COUNCIL ACTION FORM

REQUEST: **AMENDMENT TO THE ADAPTIVE REUSE PLAN AND APPROVAL OF A MAJOR SITE DEVELOPMENT PLAN FOR A FAST FOOD RESTAURANT AT 2501 GRAND AVENUE**

Attachment B: Building Elevations (Trash Enclosure)

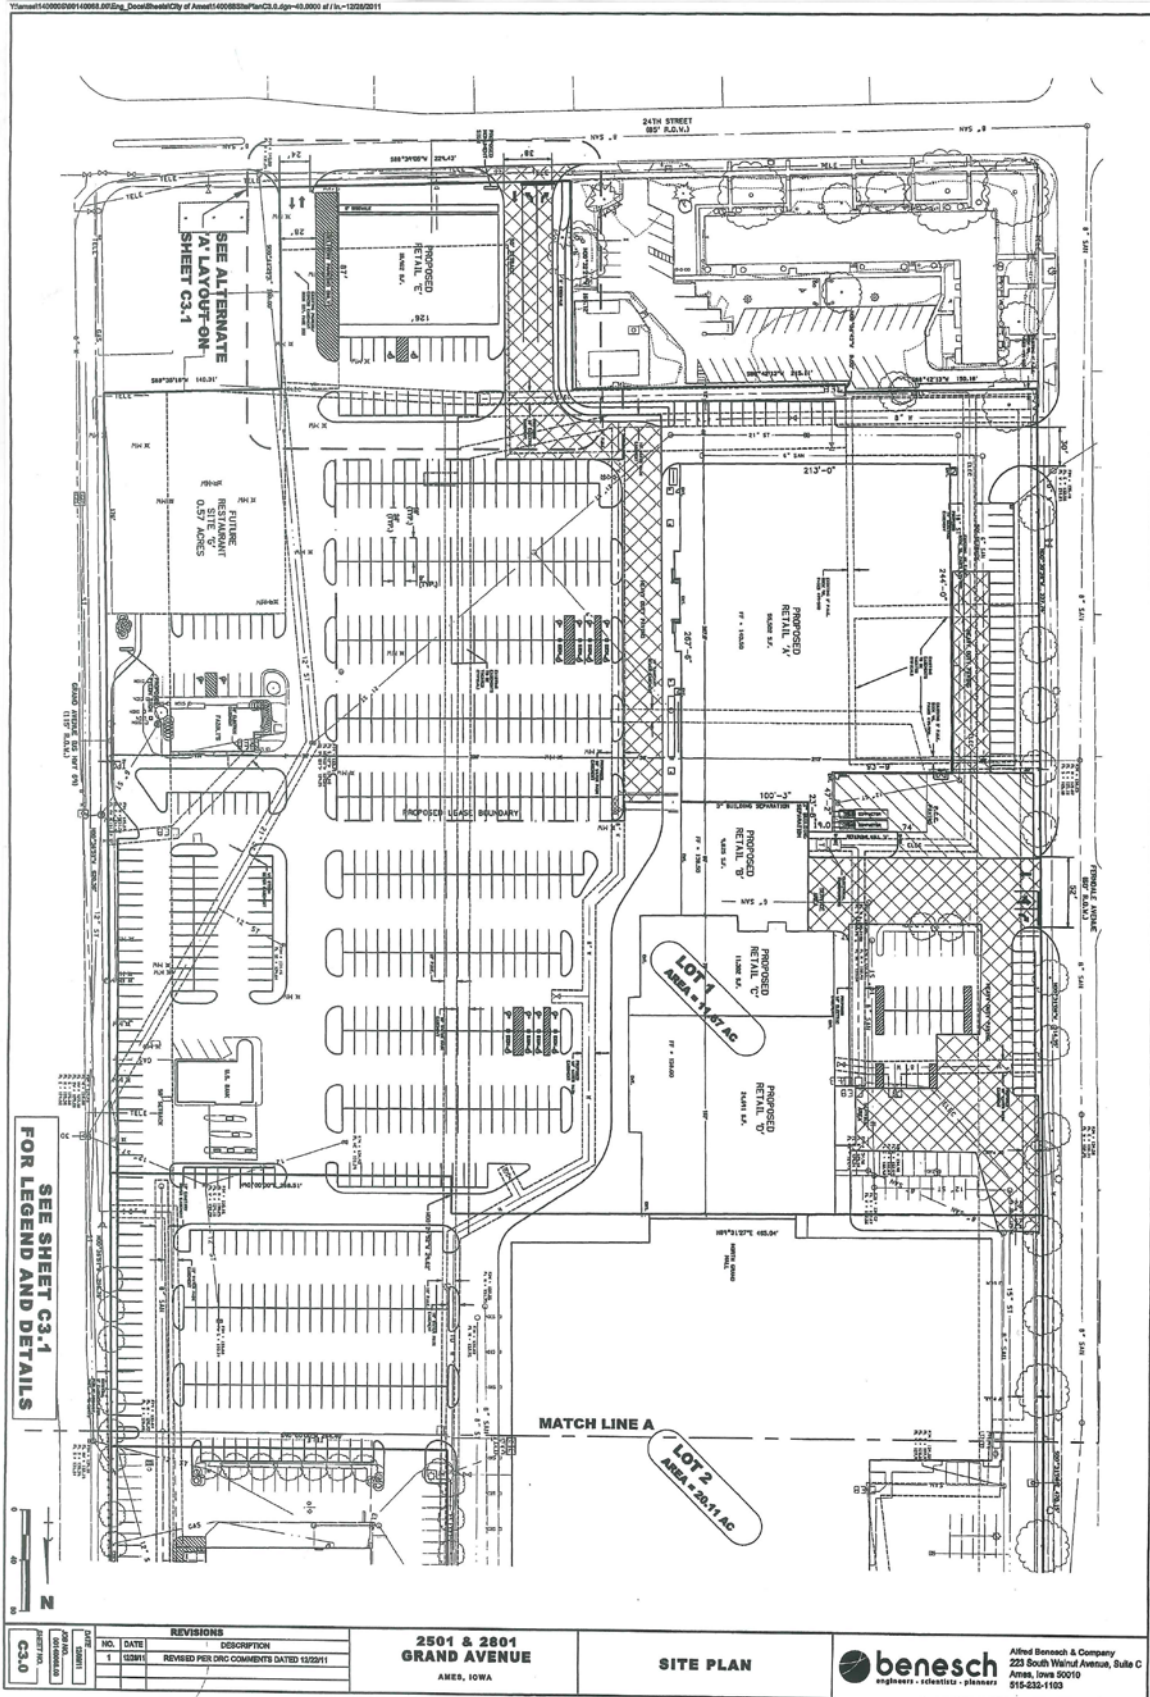
The Adaptive Reuse Plan allows for waivers of standards to facilitate redevelopment. **In this instance the project requires a waiver of the 50-foot front yard setback standards to locate a trash enclosure near Grand Avenue.** The proposed location is 10 feet from the street lot line and includes front yard landscaping between it and the street.

The garbage collection area will be screened with a fence to function as the trash enclosure. A waiver by the City Council will be necessary to allow the trash enclosure inside the minimum required 50-foot setback from the street. Other areas of the site are providing adequate landscaping to lessen the impact on adjacent sites.

- A. Provide two additional trees to meet current parking lot tree planting standards.
 - B. Waive the front yard setback requirement of 50 feet to allow the trash enclosure 10 feet from the Grand Avenue property line.

Attachment D: Major Site Development Plan (Layout & Dimensions)

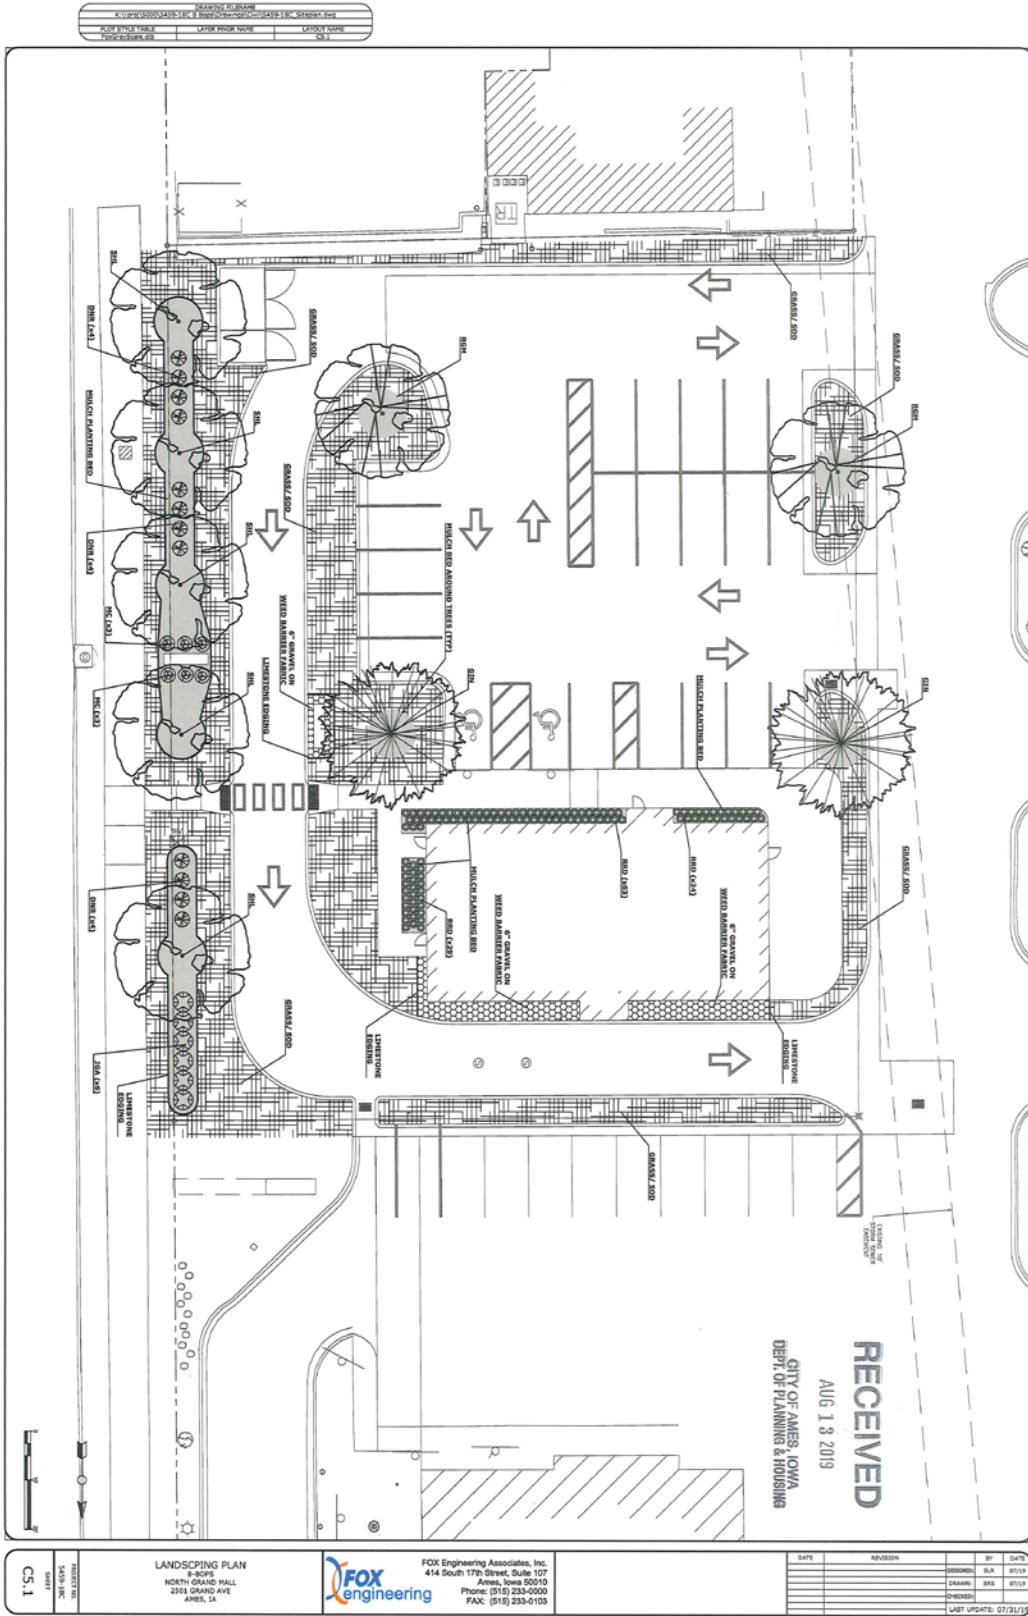
Parking. There are no existing parking spaces on the site of the proposed new restaurant that were accounted for in the prior approval. The developer proposes a total of 20 standard parking spaces, and 2 handicap-accessible. An additional 3 spaces are proposed outside the north boundary of the site (lease area). The additional spaces would be created by eliminating an access to the site from the north with Fazoli's that will no longer be needed. A total of 25 parking spaces are proposed in association with improvements for the new restaurant (22 on-site and 3 outside the lease area). See *Attachment C: Proposed Major Site Development Plan*.

A standard fast food restaurant would require 12 stalls/1,000 square feet of customer area whereas within the Mall site a 4 spaces/ 1,000 square foot standard has been authorized for uses in the 2012 Plan. The developer proposes an additional 25 parking spaces, which exceeds the number required by either the fast food standard, or the adaptive reuse ratio.

Circulation. The proposed building is designed with a drive-up service window for their customers. The stacking lane for the drive-up is accessed from the parking lot, then runs parallel to the eastside of the building next to Grand Avenue, where a menu board is located. The stacking lane continues parallel to the north side of the building where the service window is located. Exiting from facility will occur at a 90 degree intersection with the internal mall driveway.

This drive through is designed to allow for 5 cars to stack between the service window and the menu board. Approximately 3 to 4 additional cars may stack between the menu board and parking lot. Given the proposed site layout, vehicles waiting in the queue should not regularly interfere with vehicles entering and exiting the site, nor with circulation internal to the site overall. At peak times the queuing will likely reach the internal mall driveway, but should have no impact on accessing the overall mall site from 24th Street.

Pedestrian access to the site includes a proposed sidewalk, five feet wide, between the restaurant entrance and the paved multi-purpose trail along the west side of Grand Avenue. There is no walkway extension to the west towards the existing mall. Although customers at peak times may choose to park to the west of the building and walk to it, there is no means to create a sidewalk from the building that extends west to Mall building itself, only a short sidewalk extension to the curb could be added by the applicant for convenient overflow customer access to the west. ‘

The minimum required parking lot landscaping is based upon the size of the paved area of the parking lot. Overstory trees must be planted at a minimum rate of one tree for every 200 square feet of the required 10 percent landscape area. For this development a minimum of seven trees is required. The developer proposes five trees. Two additional trees may be added to meet the minimum standard. One tree could be placed in the landscape island the separates the parking lot from the drive-through land. A second tree could be placed between the east side the building and the drive-through lane. A second option would be to create another landscaped island in the parking lot to add more trees. A third option would be to add two ornamental trees along the north side of the drive-through lane. Since this is an Adaptive Reuse Plan, modifications to required landscaping can be approved.

- C. Allow the Planning Director to approve outdoor lighting consistent with the Zoning Ordinance standards.
 - D. Maintain or improve the overall parking ratio for the site and allow for development of the 2nd Amendment site area with a ratio of four parking spaces per 1,000 square feet of gross floor area for the new fast food building and provide for a total 1748 parking spaces at the completion of all improvements.
